Access Compliance Report

Public Rights-of-Way

(Curb Ramps)

Intersection ID: 7859	Main Street: MONTEITH_DR	Cross Street: SCOTTSBROOK_DR	Location: SW
ADA ID: 2D4343863AF6	Ramp Type: Perp	Initial Pass/Fail: Fail	Overall Compliance: No
		Severity Score: 1.25

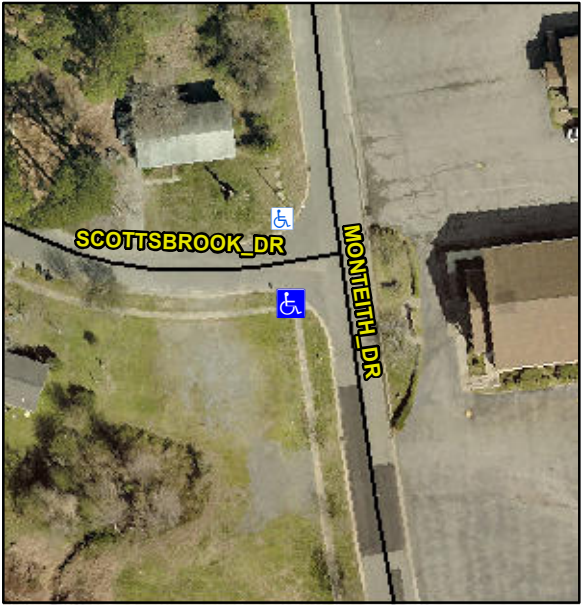
Codes/Mitigation Info/Possible Solution			Field Measurements/Component Compliance		
	Possible Solutions:		Compliance	Description	Data
	Remove & Replace Entire Ramp.		Yes	Ramp Length (in)	37.5
			No	Ramp Width (in)	60.5
			N/A	Flare Type LT	N/A
			N/A	Flare Slope LT (%)	N/A
			N/A	Flare Traversable LT?	N/A
			N/A	Landing Length (in)	N/A
			N/A	Landing Width (in)	N/A
			N/A	Landing Slope (%)	N/A
			N/A	Landing X Slope (%)	N/A
<p>Surveyor Notes:</p> <p>N/A</p> <p>PROW/ADA:</p> <p>Not Found, R304.5.3</p>			N/A	Flare Type RT	N/A
			N/A	Flare Slope RT (%)	N/A
			N/A	Flare Traversable RT?	N/A
			N/A	DWS Provided?	N/A
			N/A	DWS Contrast?	N/A
			N/A	DWS Length (in)	N/A
			N/A	DWS Full Width?	N/A
			N/A	DWS Offset (in)	N/A
			N/A	Shared Landing?	N/A
			N/A	Gutter Ponding?	N/A
			N/A	Gutter Lip Ht (in)	0.5
			No	Painted X Walk1?	N/A
				X Walk 1 Direction	To N
			N/A	X Walk 1 Width (in)	N/A
				X Walk 1 Slope (%)	0.6
				X Walk 1 X Slope (%)	0.1

N/A	Ramp inside XWalk1?	N/A
			N/A	Road Slope (%)	N/A
			N/A	Road X Slope (%)	N/A
			N/A	Any Obstructions?	N/A
				Obstruction Type	
			N/A		
			N/A		
			N/A		
			N/A		
			N/A		
			N/A		
			N/A		
			N/A		
			N/A		
Total Cost:		\$ 1850.00			
			N/A		
			Yes	Surface Condition? (G/P)	Good
